City Council Agenda Topic 3/7/16

RE: Approved HDP #6315

577 Square Feet 2nd Story Addition

518 Glen Holly Drive, Pasadena CA

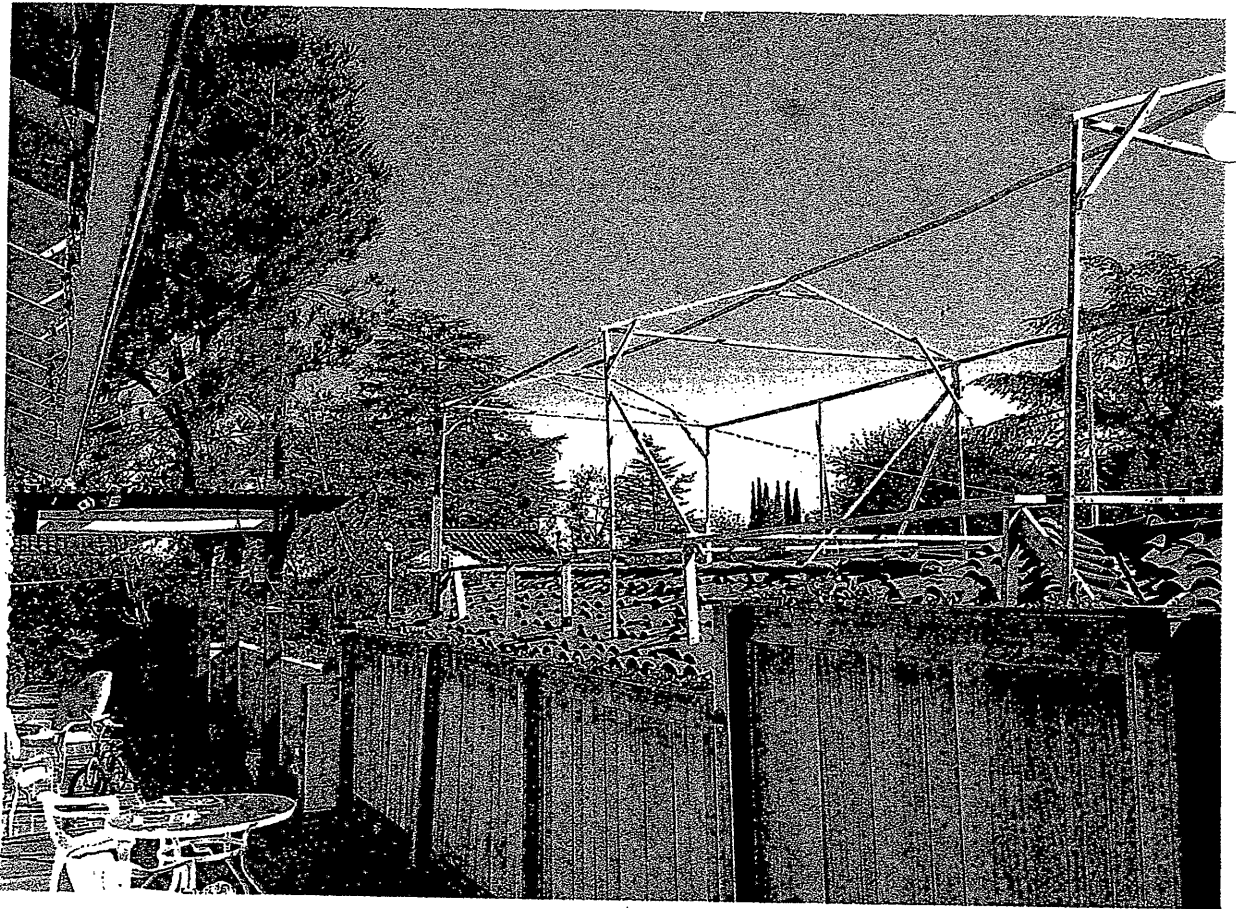
The applicant's plans do not accomplish this. On the contrary, views from living areas and the patio of our property will be very negatively impacted and also result in the loss of sun light during significantly portion of the year. I have shown in the public hearing that the project as proposed will have a huge impact on market value of our property. See next page.

2- Attached 2 pictures
